ANN ARBOR HISTORIC DISTRICT COMMISSION

Staff Report

ADDRESS: 302 East Liberty Street, Application Number HDC15-183

APPLICATION: The applicant seeks HDC approval to install a new door in a new opening on the east elevation, to accommodate a new interior lift for barrier-free access.

**PROPOSED
EAST ELEVATION**
SCALE: 1/4" = 1'-0"

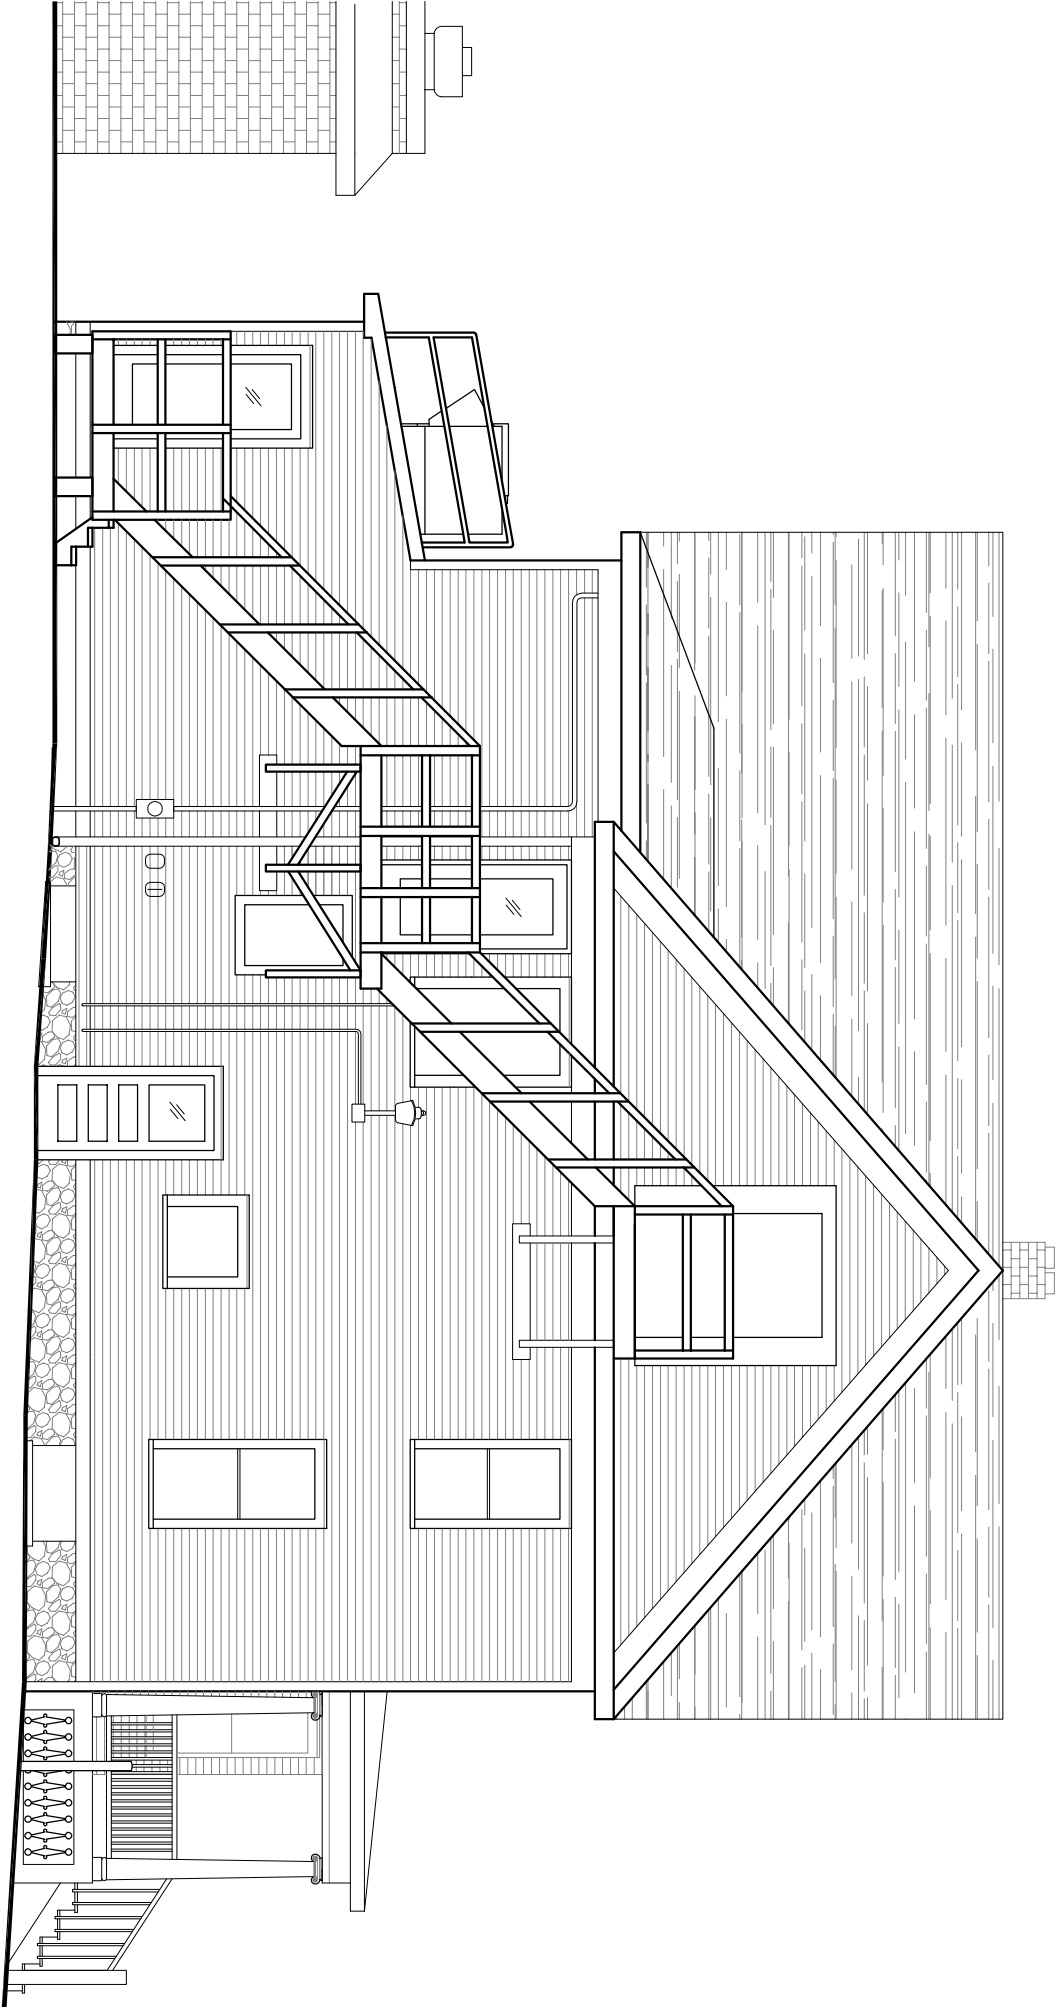
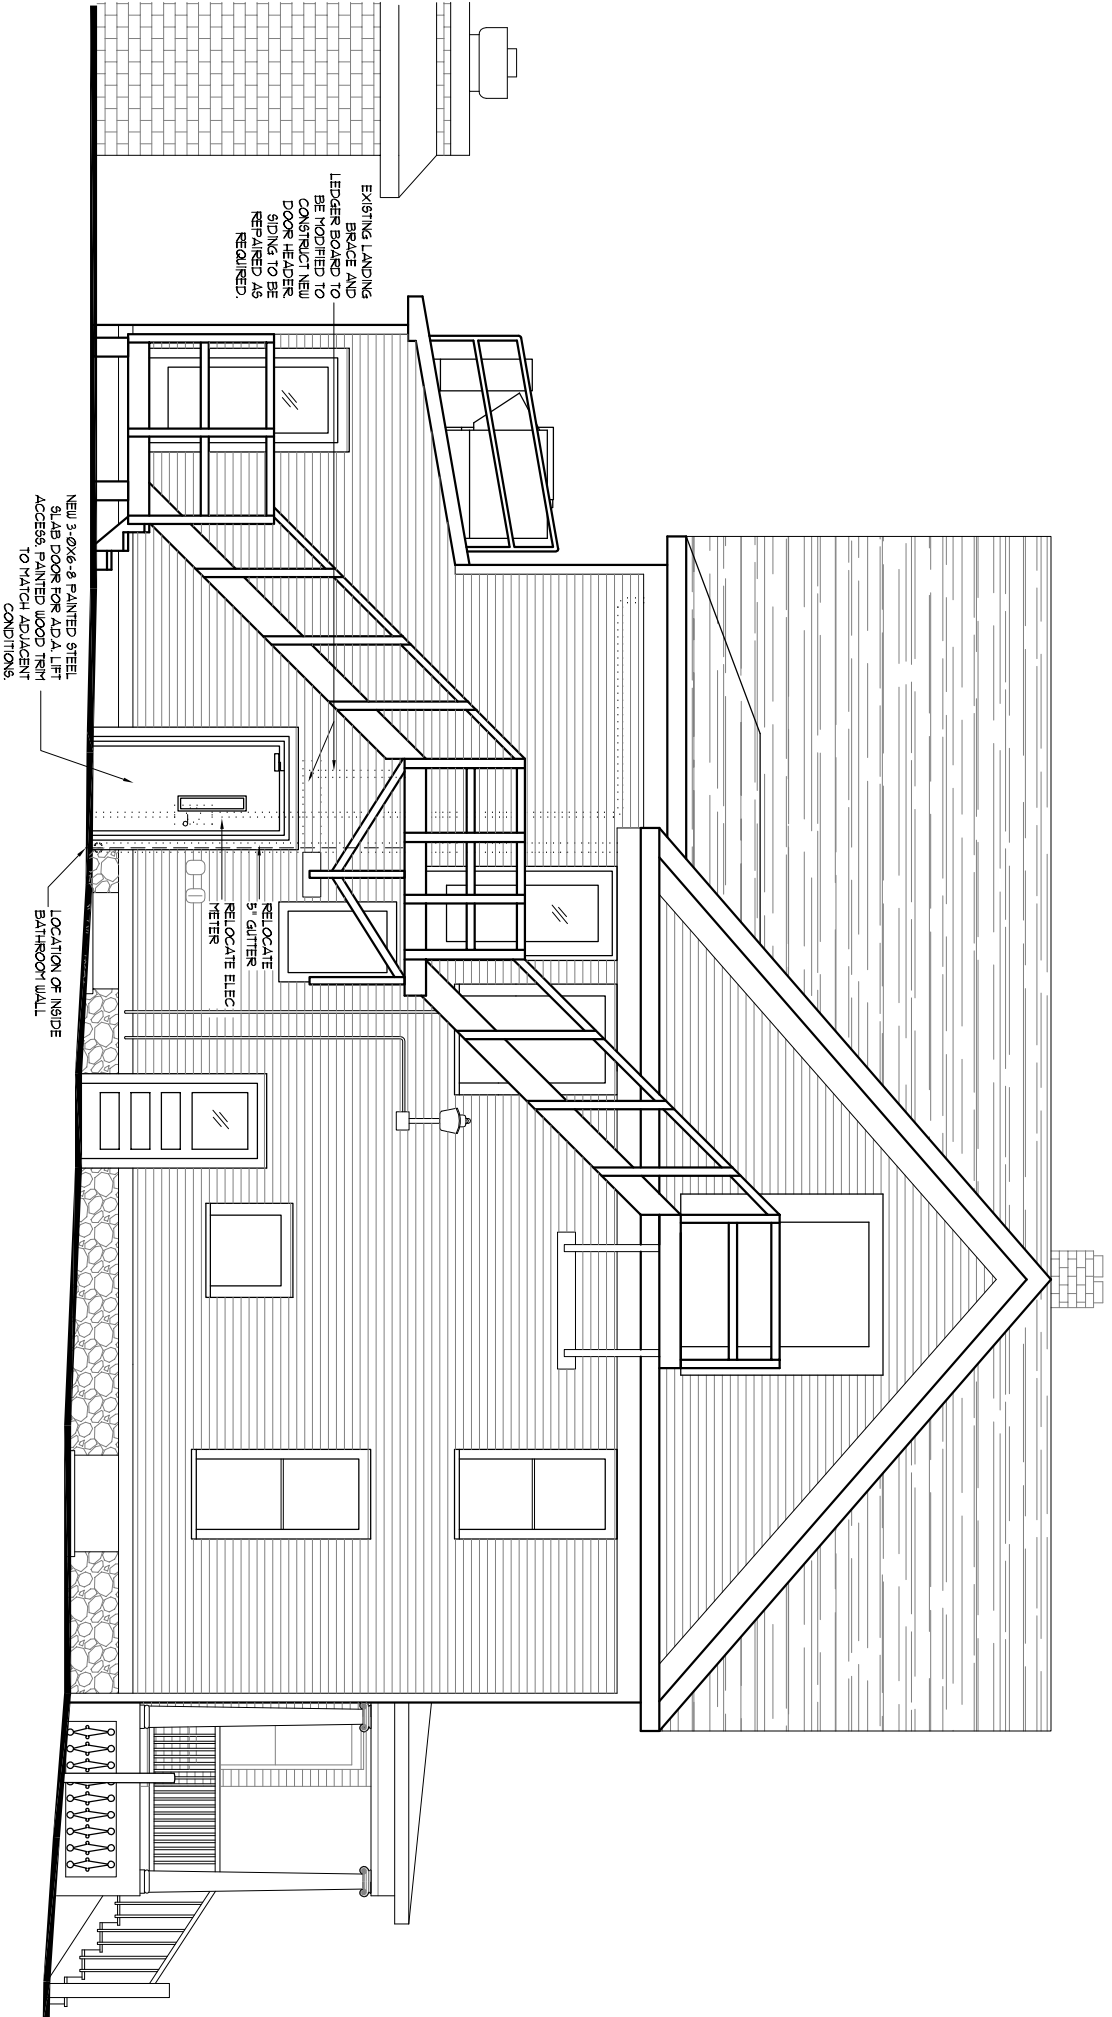
1. The proposed door is a steel slab with wood framing painted to match the house. It would be installed near the back of the east elevation, below the fire escape. The historic side door cannot accommodate the lift because it is in a stairwell leading to the basement. A door further back is too high and would require a ramp, which there is not enough room to install along the side of the house. A change in the materials of the foundation (from stone to CMU) suggests that the proposed door is on a newer rear addition to the house. The new location of the displaced electrical meter is not indicated.

2. The door's location is nearly out of sight from the sidewalk. Staff's opinion is that this additional door opening will not affect the historic building, and will provide important access to those not able to navigate stairs.
